GE Hitachi Nuclear Energy

MFN 08-304

Subject: Response to Portion of NRC Request for Additional Information Letter No. 85 Related to ESBWR Design Certification Application - Emergency Core Cooling Systems - RAI Number 6.3-64 S01

RAI Number 6.3-64 S01

Figure 6.3-64 S01-1. GDCS Line Break (Bounding Case) – Chimney Collapsed Level (72 hours)

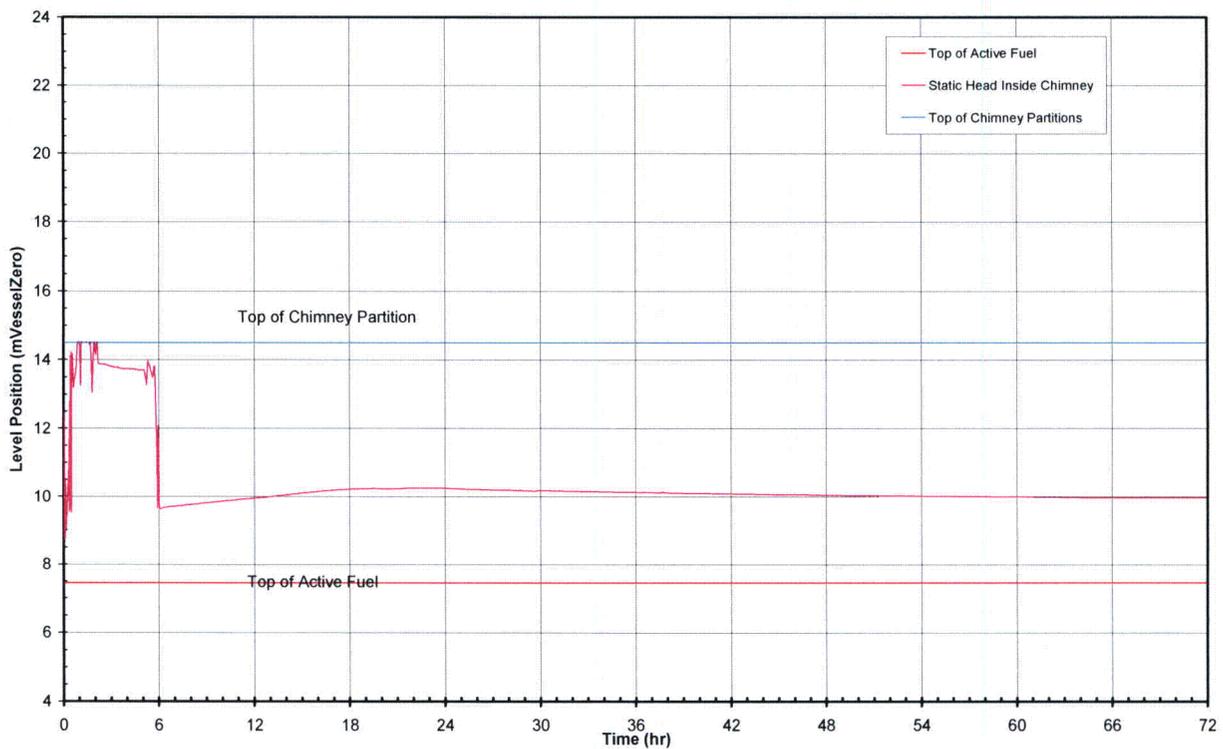
Staff requested that the applicant demonstrate the core remains covered for 72 hours for the limiting break. GE's response infers (it was not directly stated) that TRACG predicted the most limiting break for long term cooling is a GDCS line break with 1 DPV failure.

DCD, Section 6.3.3.7.9, with results displayed in Table 6.3-5, states that "the GDCS injection line break with a GDCS injection valve failure results in the lowest minimum chimney static head above vessel zero." Thus, the Staff would have expected that the RAI response provided plots of this limiting break. GE provided no explanation in the RAI response.

- A. Explain how GE came to the conclusion that the GDCS injection line break with 1 DPV failure (nominal case) is the most limiting break given the information provided in Table 6.3-5. Staff is also unclear why GE provided a plot of the nominal conditions rather than the bounding conditions for the GDCS Line break with 1 DPV failure. Include the appropriate information in the DCD.

- A. The Gravity-Driven Cooling System (GDCCS) injection line break with one depressurization valve (DPV) failure (nominal case) is not considered the most limiting break with regard to level. However, it is the most limiting GDCCS injection line break with regard to containment pressure response. For this reason, a 72-hour case already exists because the particular single failure mode will mainly impact the short-term response, and does not have a significant effect on the long-term loss-of-coolant accident (LOCA) response as was described in the original response to this RAI. The TRACG prediction of the collapsed level in chimney for GDCCS line break with one GDCCS injection valve failure is shown in Figure 6.3-64 S01-1. The minimum level of 8.50 m occurs at 593 seconds.

Figure 6.3-64 S01-2. GDCS Line Break (Bounding Case) – PCCS Heat Removal (72 hours)

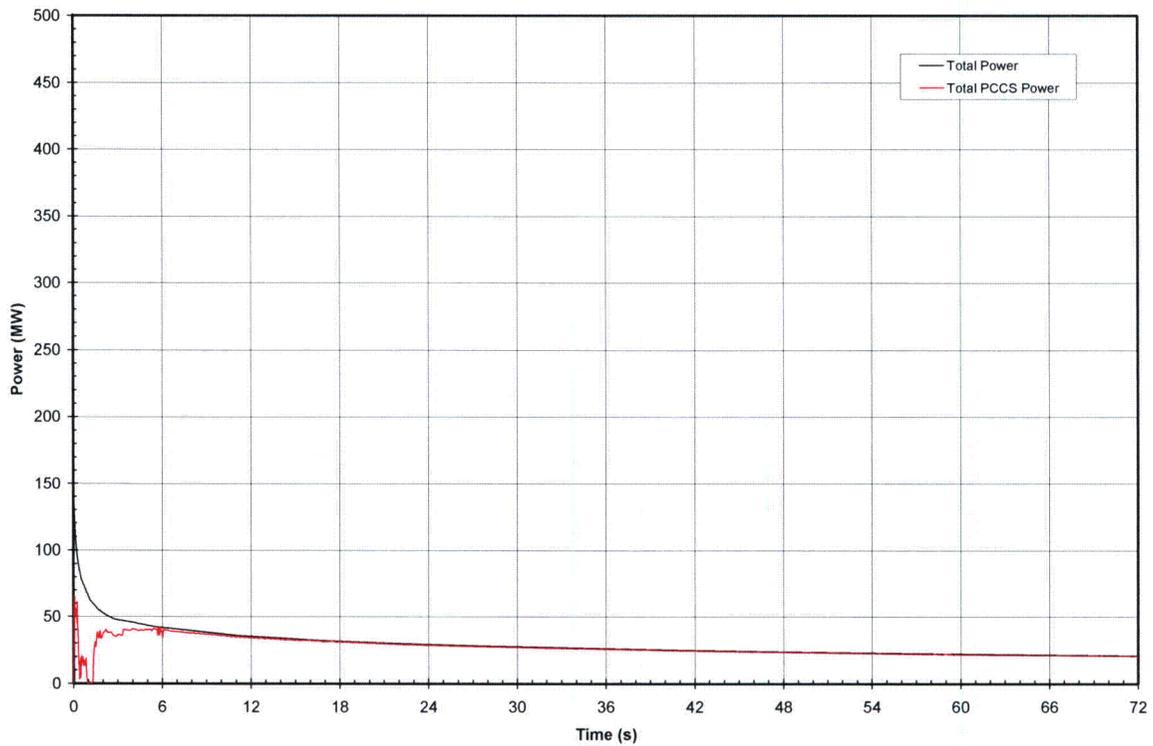
- B. Concerning the input deck assumptions, where are the non-condensable gases during the life of the transient? Staff is not convinced TRACG can accurately calculate the movement of non-condensable gases (reference RAI 21.6-96). Therefore, explain, and include in the DCD additional information regarding the treatment of non-condensable gases. Demonstrate that the treatment of non-condensable gases are conservative for long-term PCCS operation. Provide plots that show PCCS power versus time and, on the same plots, decay heat versus time.

- B. The discussion of the treatment of non-condensable gases in the analysis coverage was originally contained in the response to RAI 21.6-96 (MFN 07-348, dated June 21, 2007), and will be further clarified in the pending response to RAI 21.6-96 S01. Meanwhile, Figure 6.3-64 S01-2 contains the plot of Passive Containment Cooling System (PCCS) power versus decay heat for 72 hours from the current analysis.
